**CITY OF TEMPE  
DEVELOPMENT REVIEW COMMISSION**

**Meeting Date: 02/12/2013  
Agenda Item: 3**

**ACTION:** Request for an Amended Planned Area Development Overlay, a Use Permit, a Development Plan Review and a Preliminary Subdivision Plat for a proposed commercial development for PANDA EXPRESS RESTAURANT (PL120263) located at 908 East Broadway Road. The applicant is Hengst Streff Bajko Architects + Engineers.

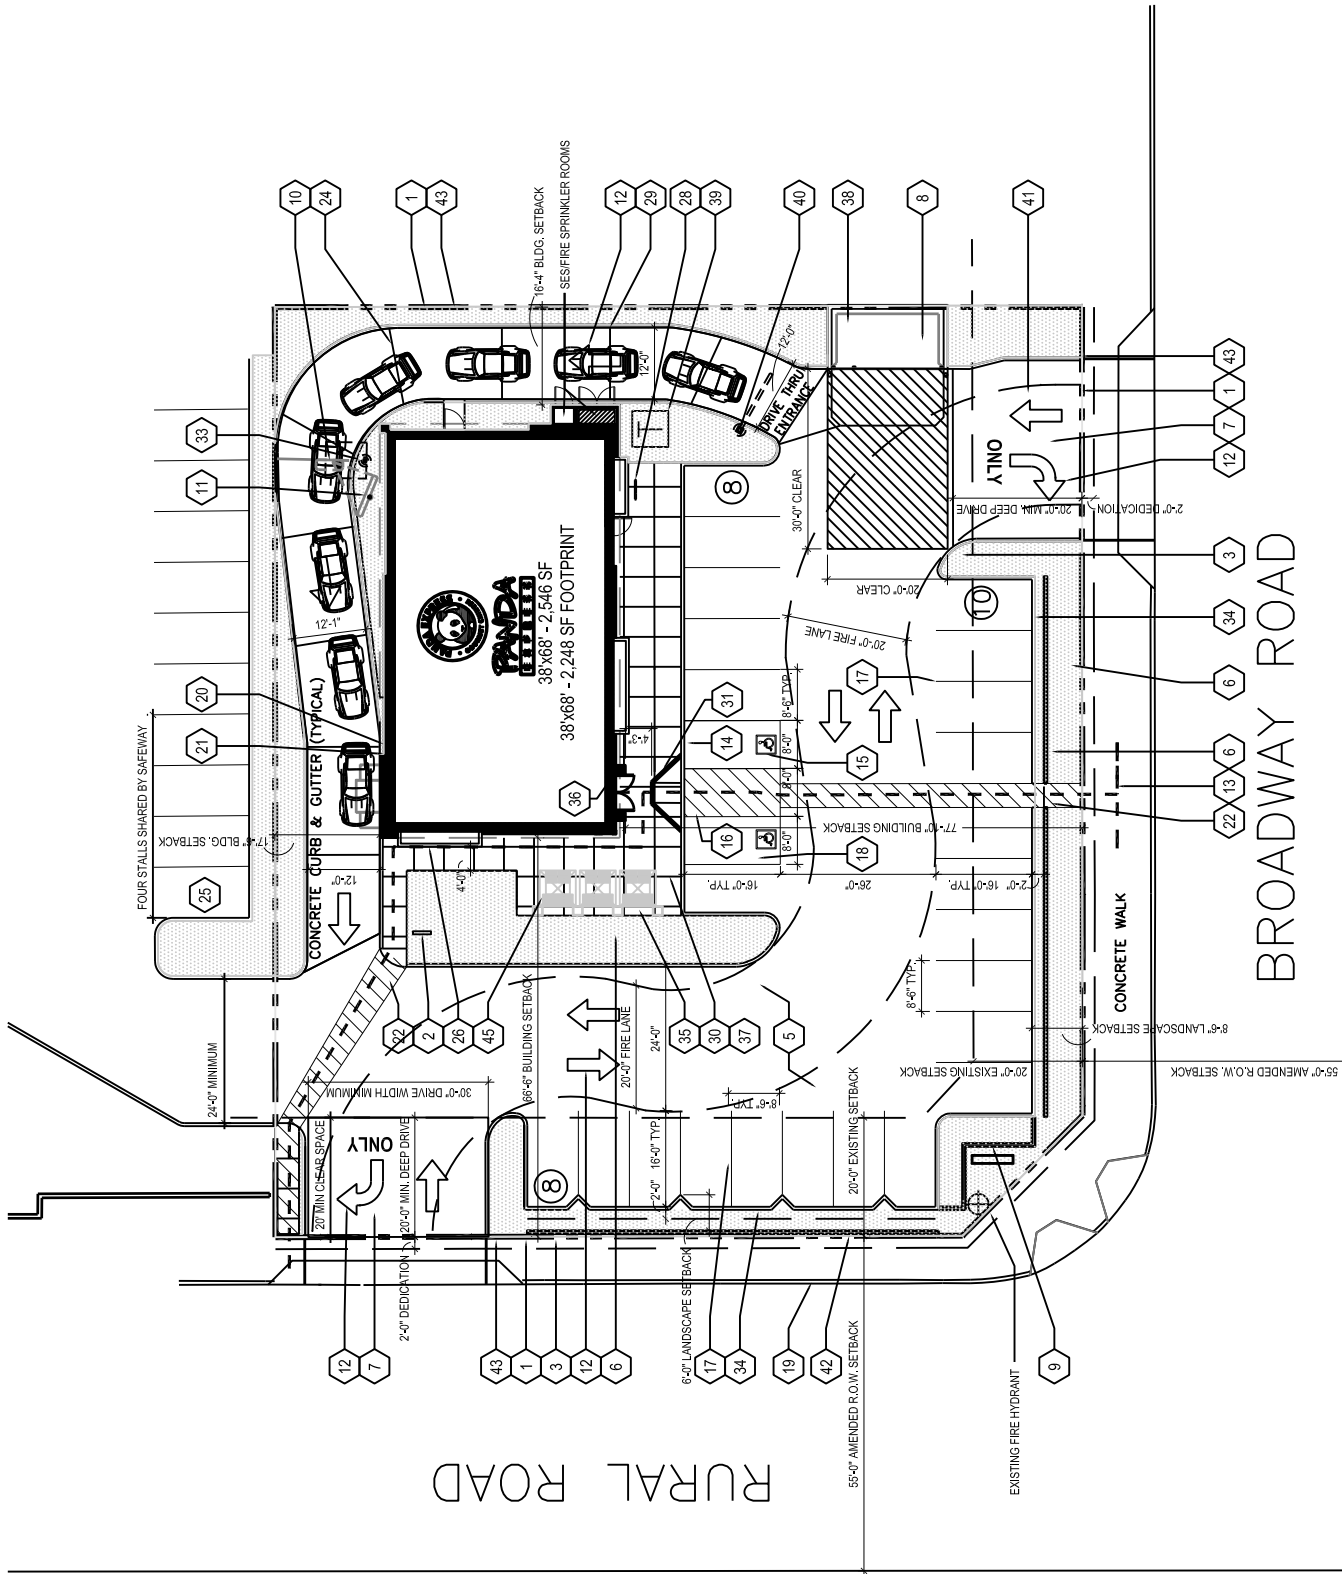
10. Adjust site plan to reflect allowable minimum vehicle parking setback on both frontages. Provide parking screen wall adjacent to right of way line and provide 45 degree landscape indents for trees in parking spaces on both frontages, not just on the Rural Road frontage.

12. Provide upgraded paving at each driveway apron consisting of unit paving or an uncolored concrete repetitive joint pattern that compliments the building design. Extend upgraded paving in each driveway from back of disabled accessible sidewalk bypass or right of way line (whichever is closer) to 20'-0" on site and from curb to curb at the drive edges. If space exists in the public right of way between the right of way line and the back of sidewalk bypass, increase the bypass width so it touches the right of way line.

13. Provide concrete disabled accessible walkway from Broadway Road to business entrance that is flush with asphaltic concrete pavement in parking lot. Do not stripe this walkway except at disabled accessible parking side aisle.

**Panda Express – Landscape Plan**

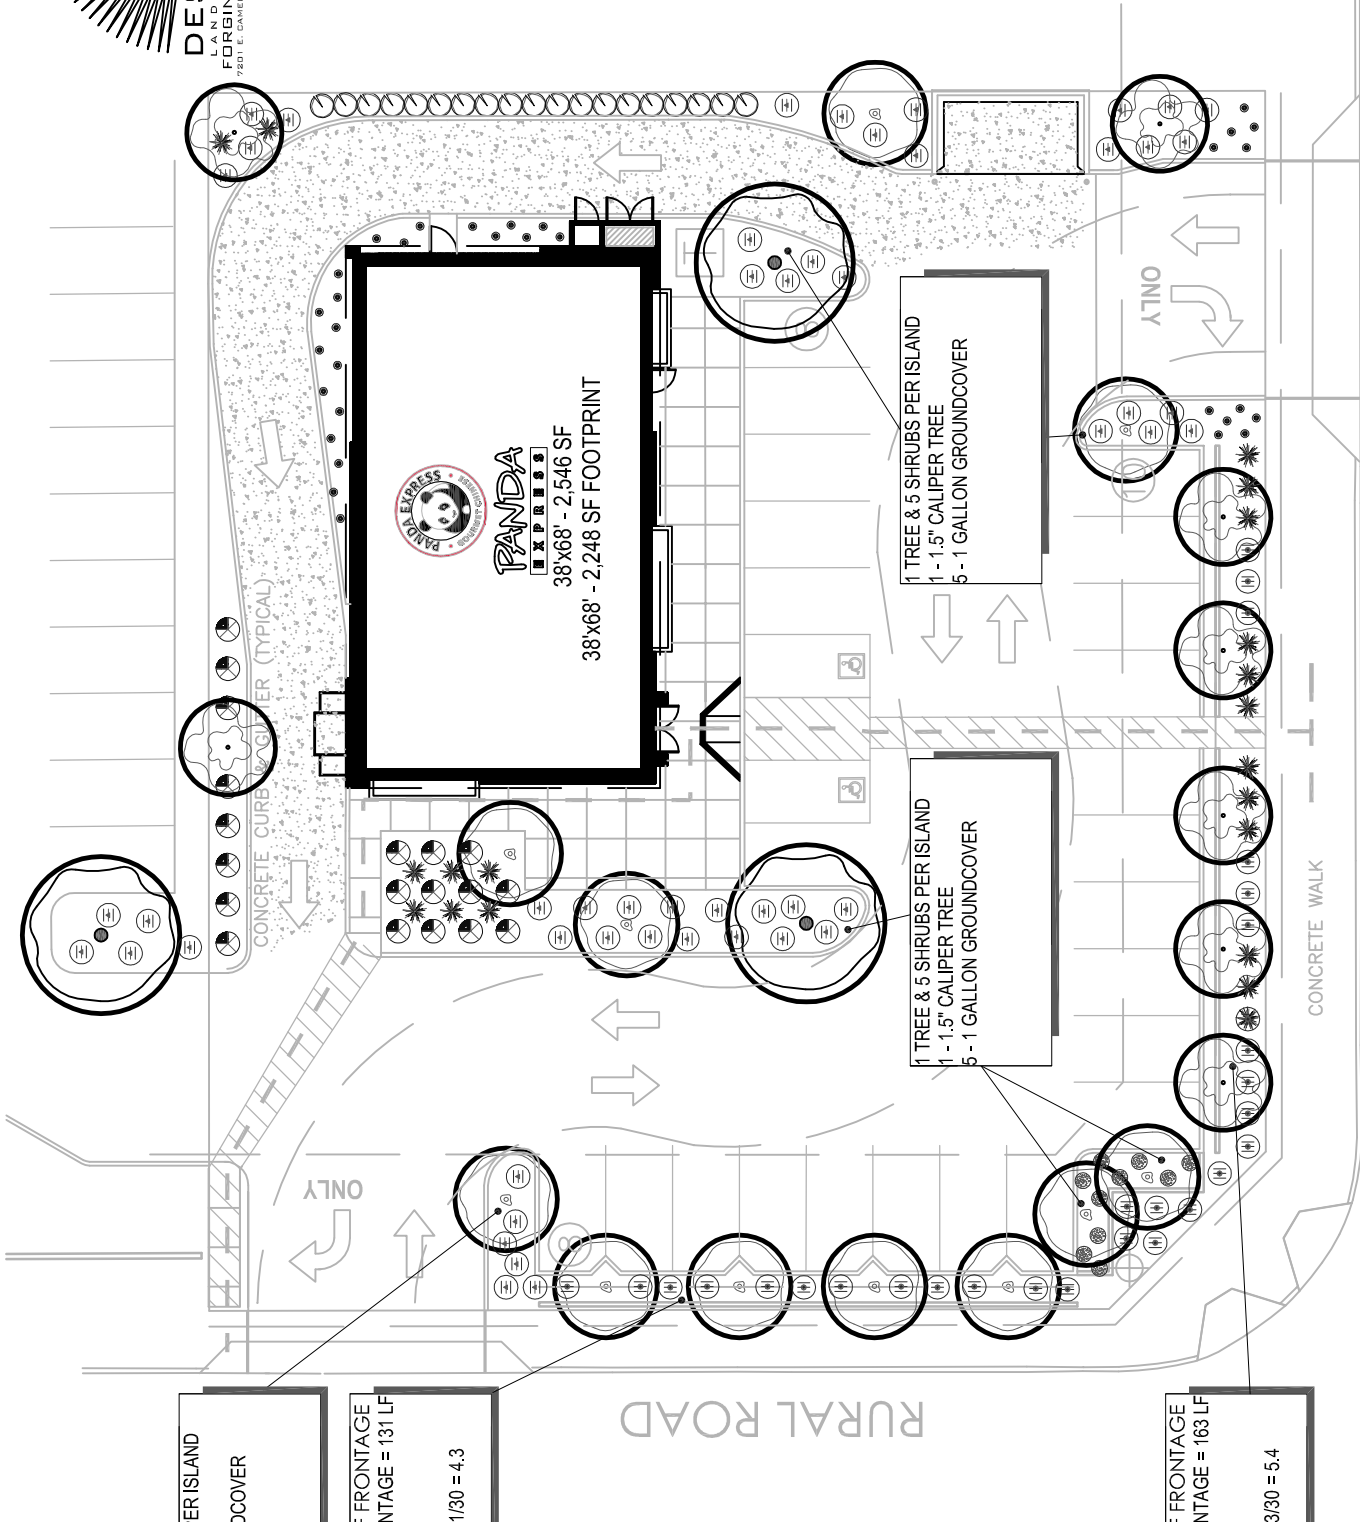
21. Do not propose Texas Ebony street trees. Provide street trees that are a thorn-less cultivar of Palo Verde or a similar tree type that quickly mature with an open growth habit, that may be pruned with a tall canopy understory as they mature (so a sight line is quickly established between business and street under the canopy), and do not pose a scratch hazard to restaurant patrons or the public. See the southeast corner of McClintock and Broadway for an example.

22. Indicate existing trees to remain on site and identify by species. Where an existing tree indicated to remain dies or shows probability of dying prior to conclusion of this project, replace with a tree of minimum 48" box installation size that compliments the landscape design.

24. Top dress planting areas with a decomposed granite application of a beige or sand color. Provide 2" uniform thickness as indicated. Don't install river run rock, granite cobble or similar pieces between 2" and 12" diameter unless pieces are embedded in a concrete substrate to prevent removal for vandalism or assault. Till and loosen soil in planting areas. Remove debris from planting areas prior to landscape installation.
